**Expert Witness Report**  
of  
**Dr. Timothy D. Bechtel**

Dr. Timothy Bechtel, Geophysics, Staff Associate, TETHYS Consultants, Inc., will testify as to the migration offsite of contaminants in the groundwater from the landfill and the use of groundwater background levels that are not representative of uncontaminated groundwater.

I have completed a review of available hydrogeologic data concerning Modern Sanitation Landfill (Modern Landfill or the "site") in York County, Pennsylvania. The purpose of the review was to evaluate the potential impact of the landfill on the regional ground water system -- particularly the ground water beneath the 17 acre northern expansion, and the ground water used by local residents. The following report does not attempt to present a comprehensive summary of the local hydrogeologic conditions of history -- such summaries are contained in many public record documents (see below). Instead, this report addresses three geologic and hydrogeologic issues that have been questioned by local residents and/or (in my opinion) have been inadequately addressed in previous studies and comments/responses by PADER and USEPA (note: please refer to Appendix A for d

**Figure 3 and 4, Ground Water Contour Maps**

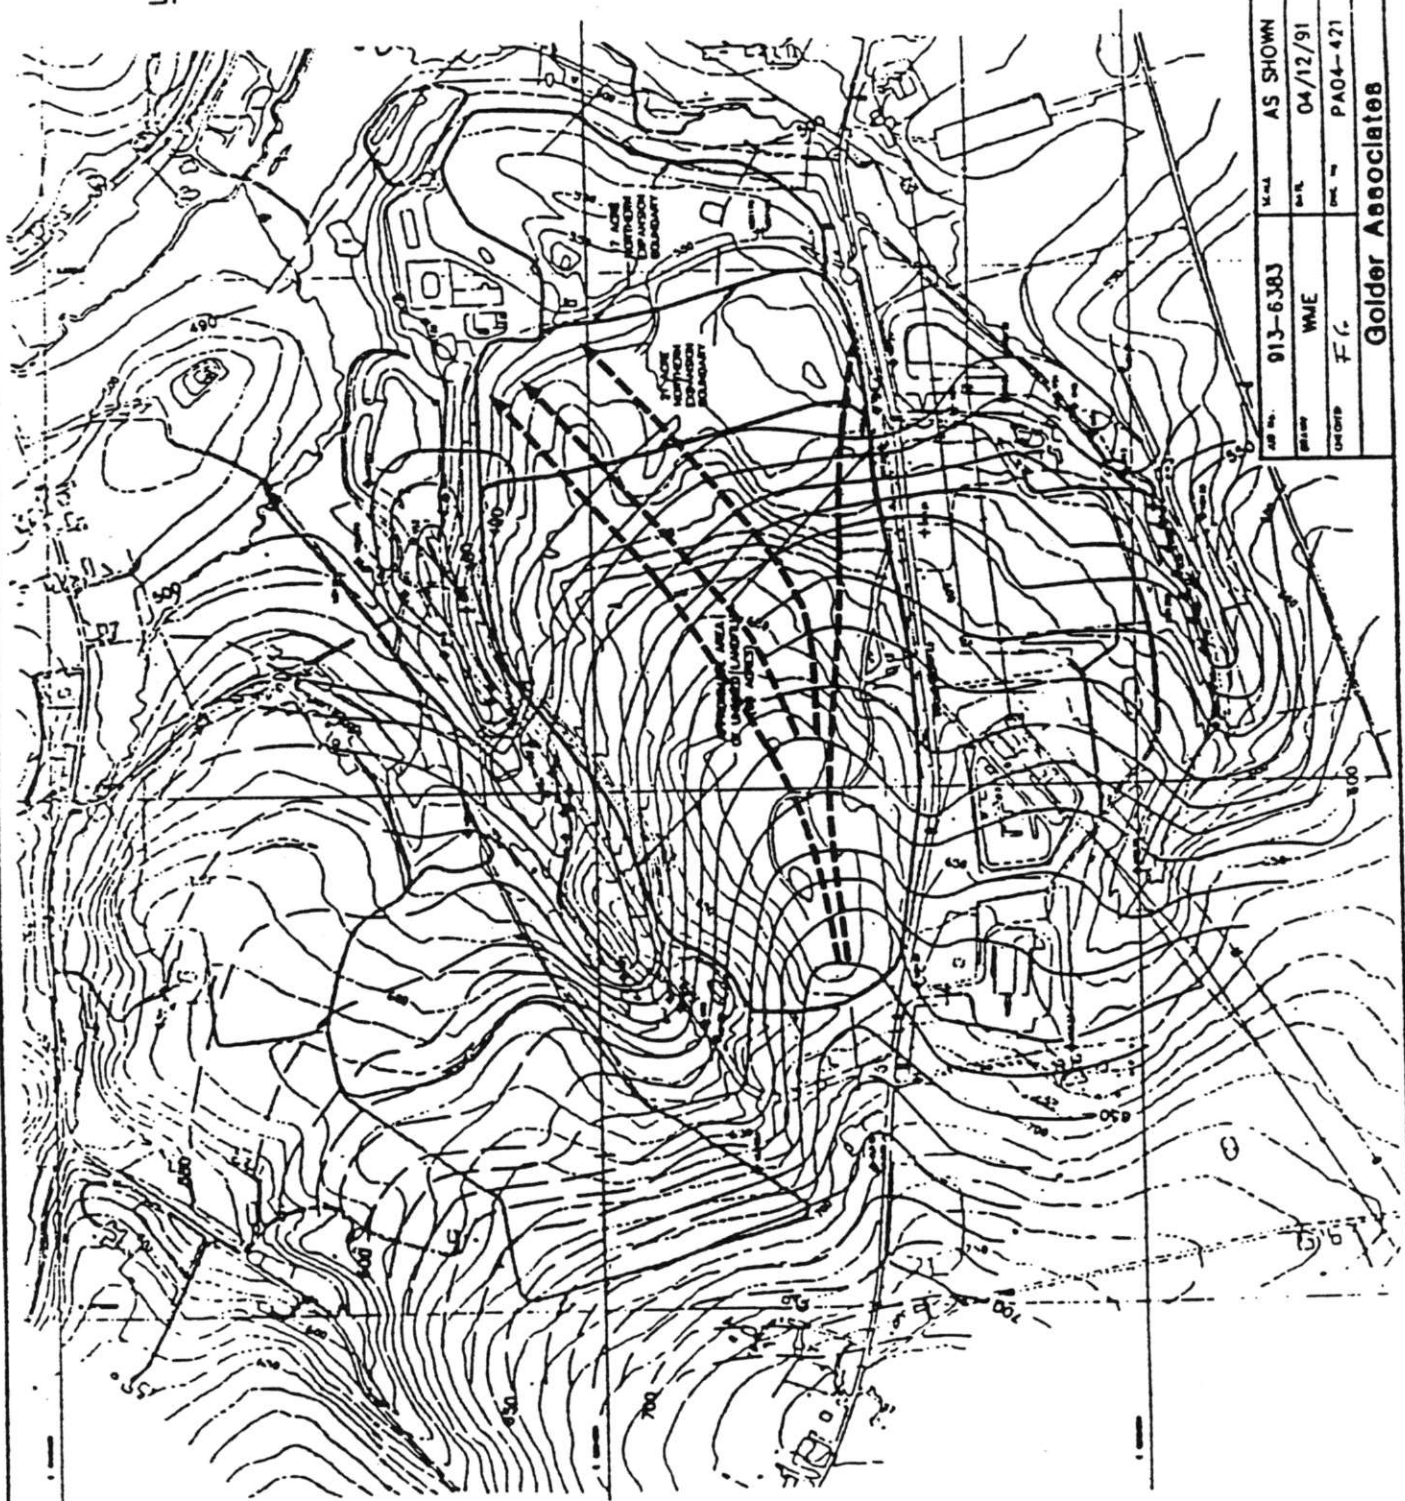
Installation of the western ground water interceptor trench (1977), the western extraction system wells (1985, augmented 1987), and the eastern extraction system wells (1986) have dramatically altered the original flow as depicted on the enclosed maps (from the 1990 Groundwater Extraction System Annual Assessment). The purpose of the alteration is to capture any contamination originating beneath the unlined portion of the landfill. However, examination of the ground water contour maps suggests that the extraction systems cannot possibly be capturing all of the northward flow. Ground water that flows along the ridge defined by the contours can escape directly north beneath the 17 acre expansion without being pulled to the east or west. This is depicted on the April, 1989 and September, 1990 ground water contour maps in Appendix C (from the 1990 Groundwater Extraction System Annual Assessment). Flow paths for several water particles have been sketched (dashed lines) by directing the path to be perpendicular to each contour that it crosses (a physical necessity). It can be seen that ground water which has passed for relatively great distances beneath the unlined landfill (thereby picking up leachate components) must flow beneath the 17-acre northern expansion.

**Figure A-9 and Figure A-10, Capture  
Zone Simulations**

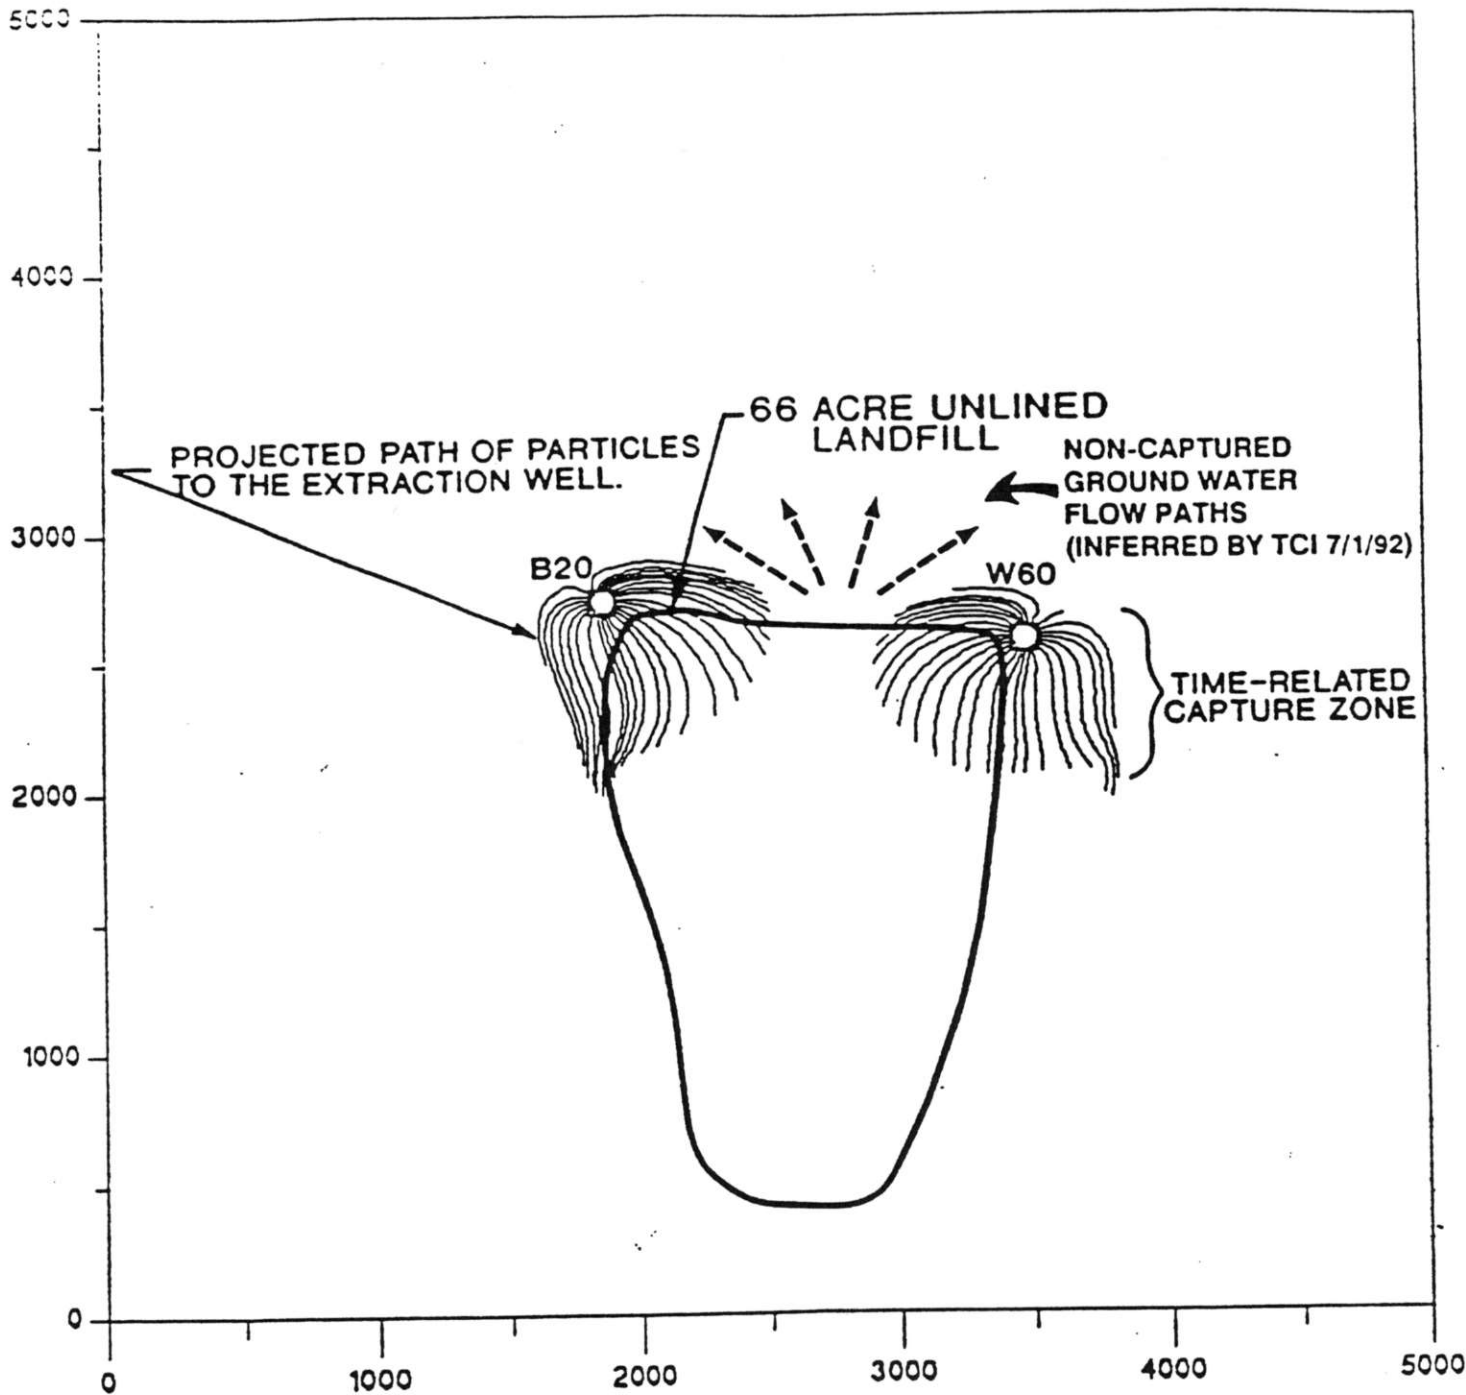
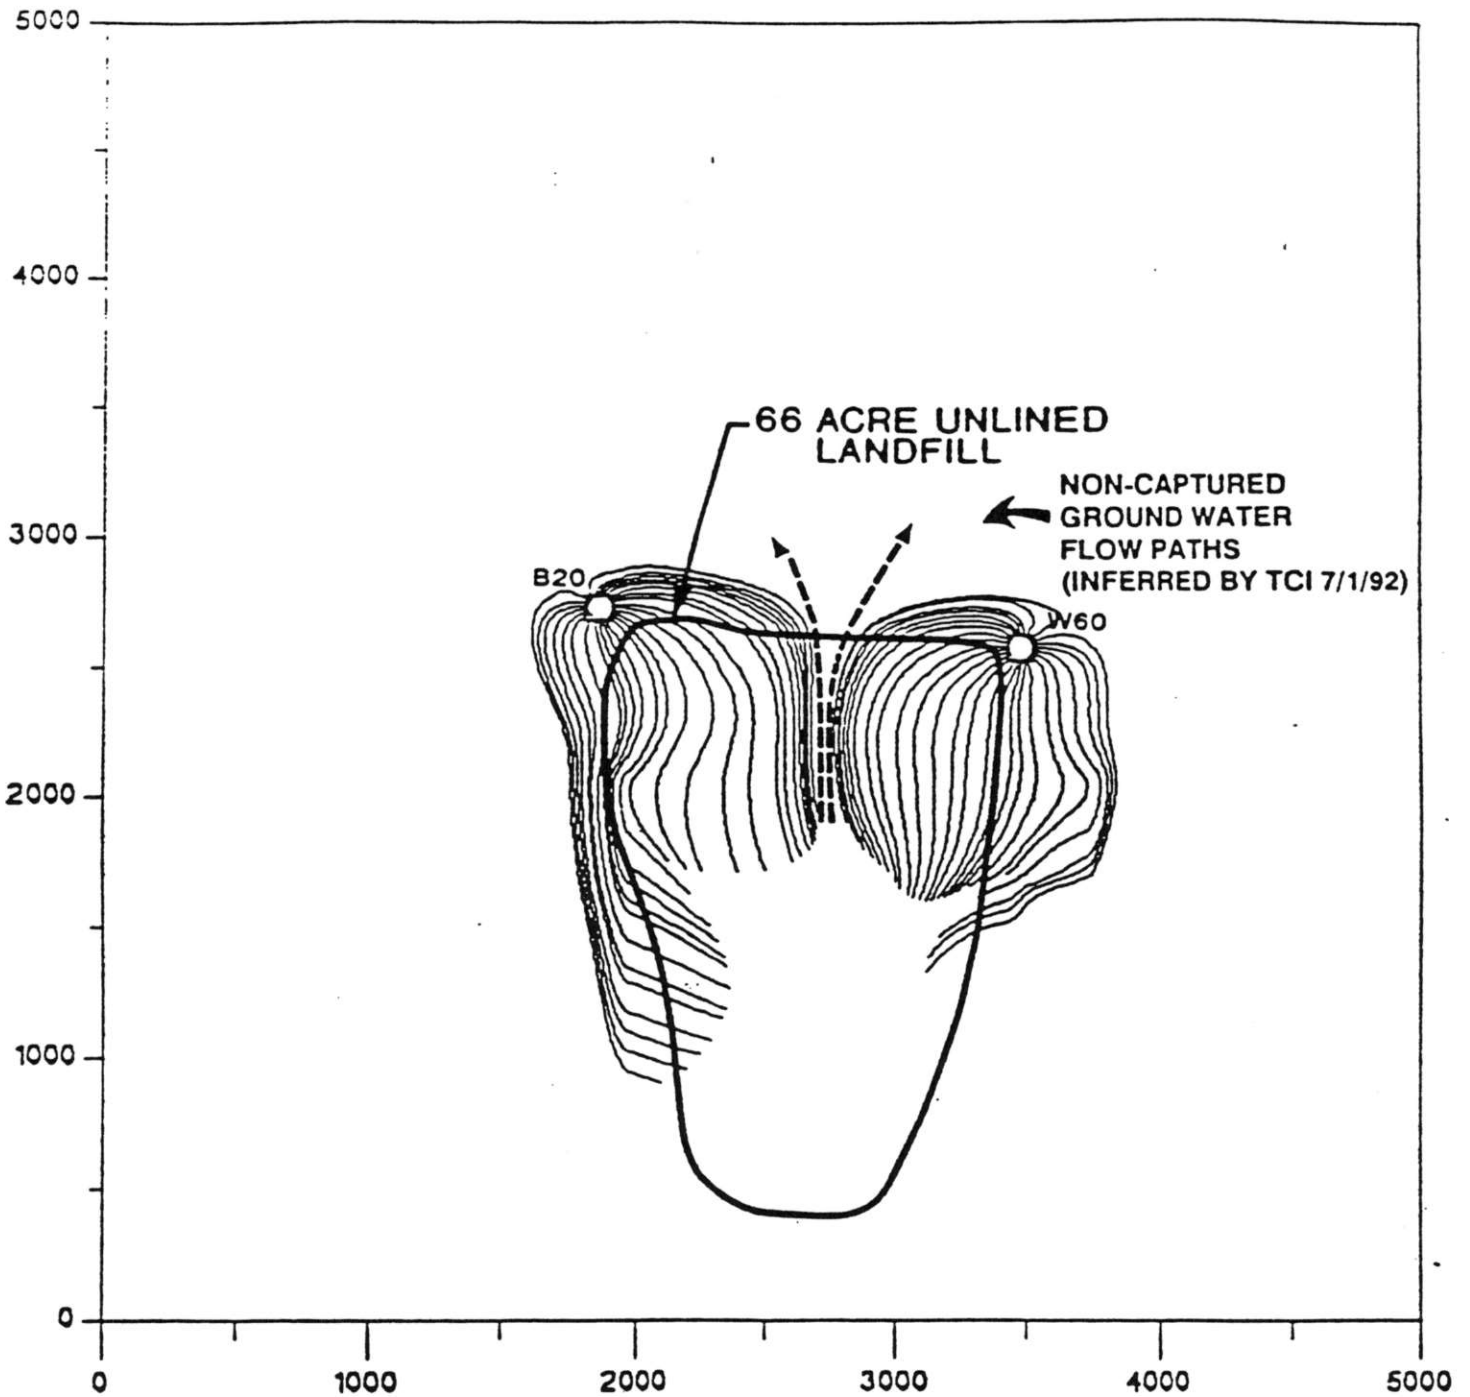
A June, 1991 Appendix to the 1990 Ground Water Extraction System Annual Assessment evaluated the effectiveness of W60 and explored possible enhancement strategies for the western system. This study did contain the results of ground water flow path modelling as shown on the capture zone simulations enclosed in Appendix C. Figures A-9 and A-10 (from the above-referenced June, 1991 Report, and Appendix C of this report) depict the capture zones for the northernmost extraction wells. Note that these capture zones are based on the actual construction and pumping rate for W60, but for B20, the capture zones are based on a proposed deepening and enhanced pumping rate. Therefore, the actual capture zone for B20 may in reality be considerably smaller. Note also that even the five year capture zones leave a narrow flow path from beneath the unlined landfill to the 17 acre northern expansion. Interestingly, well MD115D (the closest well to this predicted

northern escape route) has, in fact, tested positively for leachate VOCs on five separate occasions.
